SUBJECT: COMANCHE PEAK NUCLEAR POWER PLANT, UNITS 3 AND 4
DOCKET NUMBERS 52-034 AND 52-035
RESPONSE TO REQUEST FOR ADDITIONAL INFORMATION NO. 5854
(SECTION 11.2)

RAI NO.: 5854 (CP RAI #224)

SRP SECTION: 11.02 - Liquid Waste Management System

QUESTION NO.: 11.02-18

Figure 11.2-201 Liquid Waste Management System Piping and Instrumentation Diagram (Sheet 9 of 10)

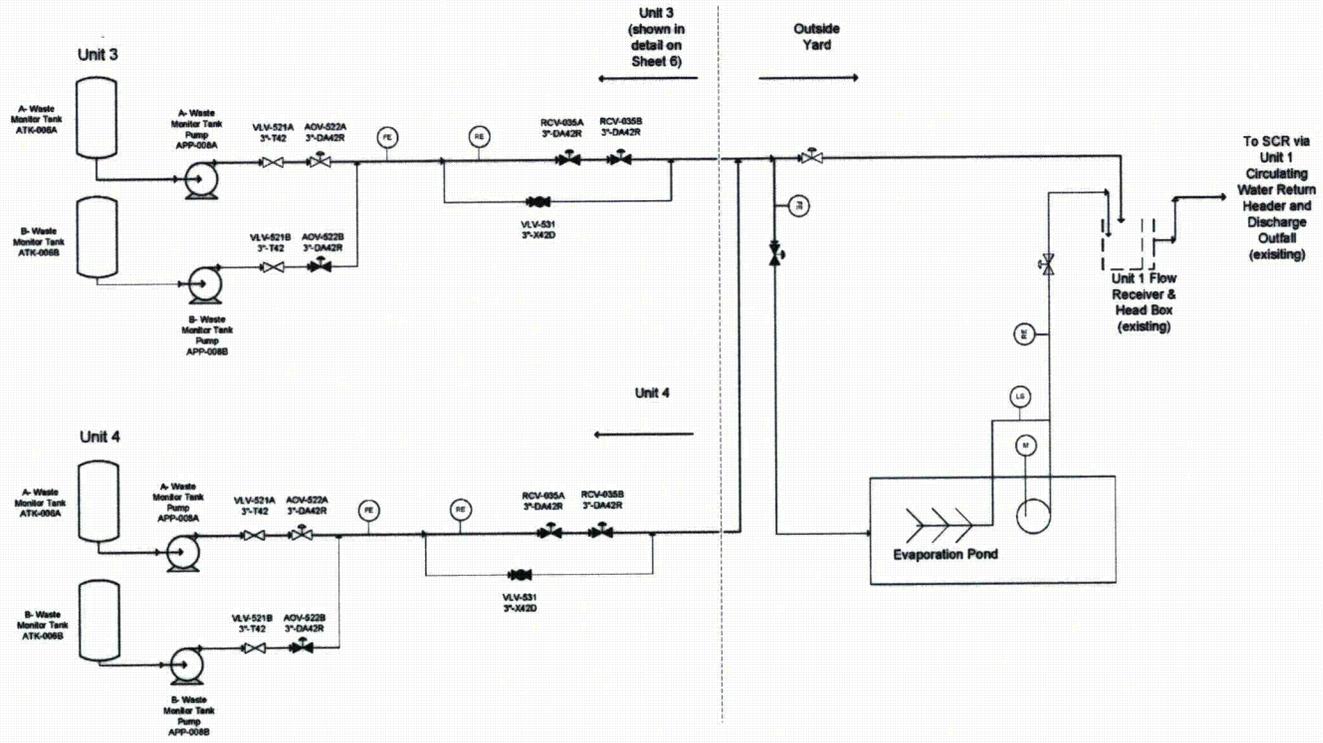
The staff's review of FSAR Section 11.2 and of the applicant's responses to related RAIs on the evaporation pond found that design information on site-specific sample points and locations was not fully described. These site-specific sample points, that ensure that representative samples of the evaporation pond are taken before its contents are transferred to the SCR via the CPNPP Units 1 and 2 circulating water return line, are planned to be located during the "detailed design." In FSAR Section 11.2, please describe the "detailed design" information on the site-specific sample points and locations; discuss the operational program and applicable procedures and NRC guidance; and identify the sample points and locations on a P&ID of the evaporation pond that will satisfy its stated design objective.

FSAR Sections 2.4 and 11.2 have been revised as reflected in the attached markups. The changes are mainly editorial for reorganization and clarification. The design and basic operation of the evaporation pond have not been changed. However, the previous FSAR information about multiple effluent samples

around the pond perimeter has been replaced with new design information about the circulation of the evaporation pond contents as discussed above.

The evaporation pond discharge pump also acts as a recirculation pump for the pond. The pond is recirculated sufficiently to obtain a representative sample at the discharge pump before discharging the pond contents to the CPNPP Unit 1 flow receiver and head box.

The evaporation pond discharge pump and discharge isolation valve are under supervisory control.
